Product Change Notification

Change Title	2.5" SATA 3SE-P/ 2.5" SATA SSD 3SR-P PCB Change Notice	Date	2020/03/23	PCN No	F2012
PCN level:	Minor				
Models:	2.5" SATA 3SE-P/ 2.5" SATA SSD 3SR-P				
Category:	Hardware - PCB

B version PCB (Immersion Silver)	C version PCB (ENIG Process)

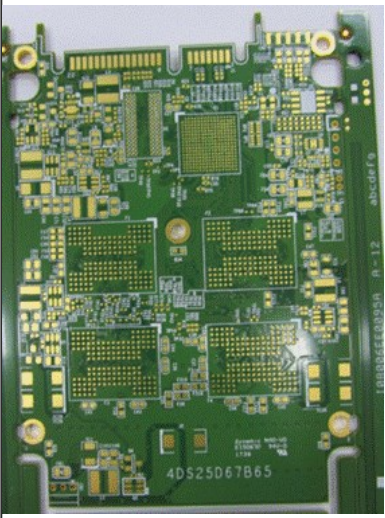
This PCN is being issued to address that Innodisk 2.5" SATA SSD 3SE-P & 2.5" SATA SSD 3SR-P are going to update PCB version, changing from immersion silver to ENIG process.

There are no changes to specifications or function, and the part number will evolve to C version from B version on PCB code.
